Technical Note

Project Mayfield Appointments 2020
Subject Information to Support Discharge of Condition 10 and Condition 22 – Application Ref. 124972/FO/2019
Project no 0046688
Date 20 April 2021

Figure 1: Baseline water level at the Wildscape area, annotated with location of cause of mass error

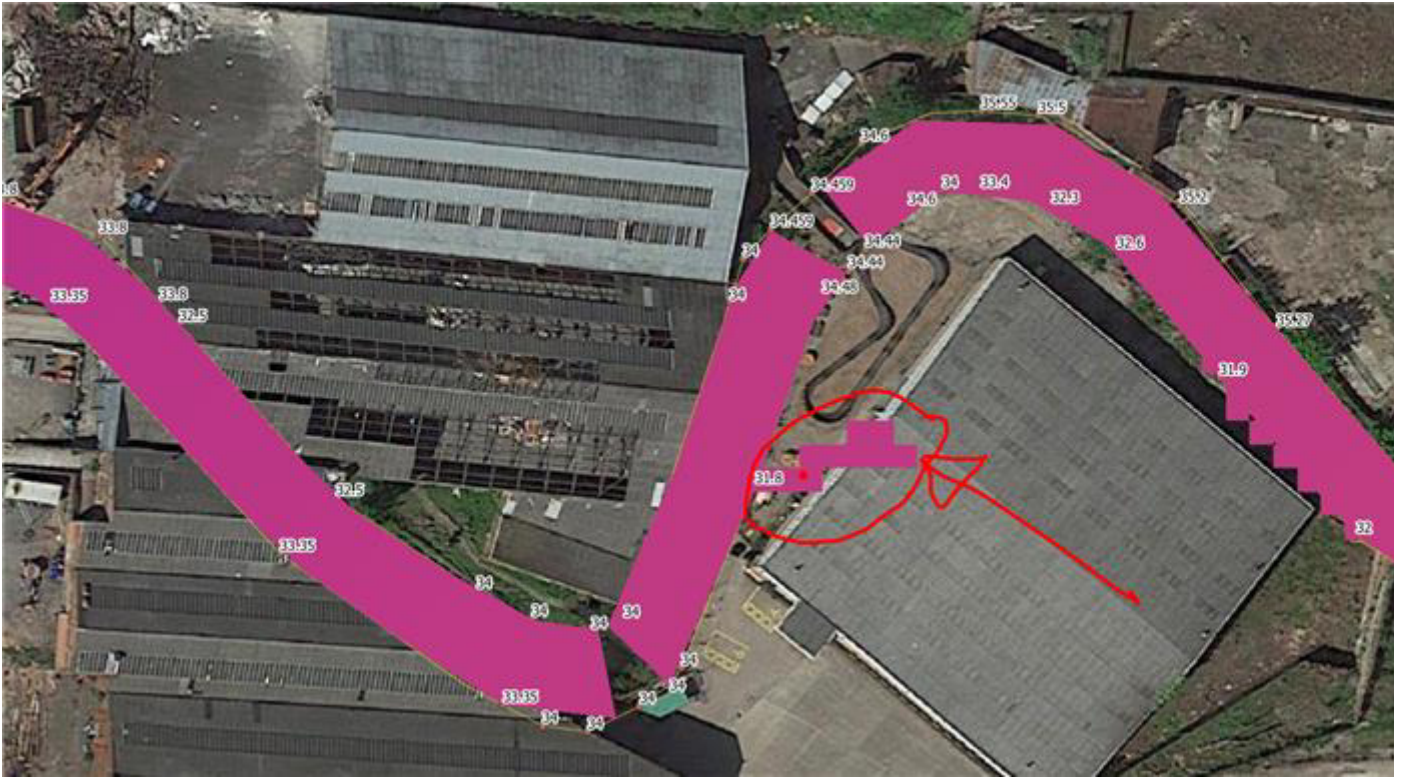
- Accumulation of mass error occurs between the hours of 0 and 2, when flow in the river is low, and in-channel water levels are very similar to the low point of the bank;
- This causes constant flux between the 1D and the 2D domains at the part of the Wildscape area circled in the image in Figure 1, with no clear dominant flow direction;
- Concluded that this flux is the cause of the peak in mass error, as cumulative mass error begins to reduce as water levels increase (Figure. 2).

- Raise bank height from 31.8mAOD to 32mAOD locally, at inflow point from channel to Wildscape area, to match proposed level for low point of Wildscape area
- This prevents movement between 1D and 2D domain during low flow state (hours 0 to 2) and significantly reduces the mass error (Table 1 and Figure 3)
- This amendment is considered a more accurate representation of the proposed scheme, rather than a design change, and does not have an impact on water levels elsewhere within the model

Figure 3: Comparison of cumulative mass error for the 100 year + 35% CC event for the Baseline and Full Build Out models

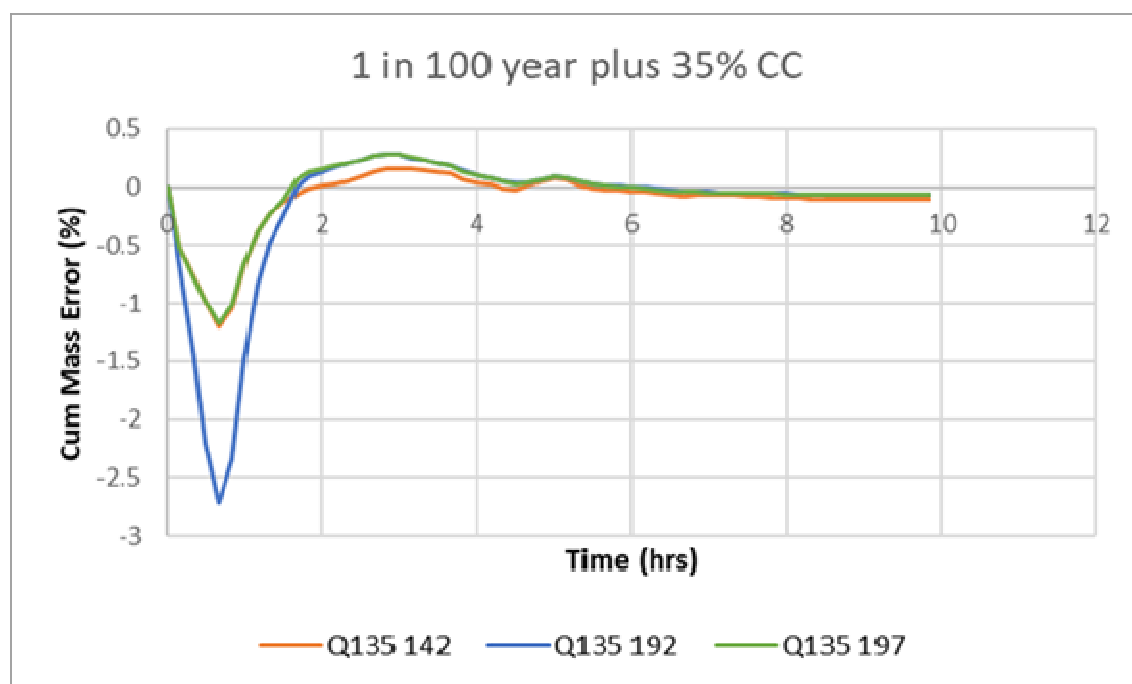
- **The 1D channel cross sections and structures do not appear to match the plans provided.**
- **2D mass balance error is out of tolerance (+/-1%) indicating model instability. This should be reviewed and improved.**

Table 1 provides a summary of the mass error for each run and return period, indicating that the amended Full Build Out model (197) has a maximum mass error of -1.19%, which matches the performance of the Baseline model (142). Although this exceeds the threshold of $\pm 1\%$, this is considered appropriate given the prior approval of the Baseline.
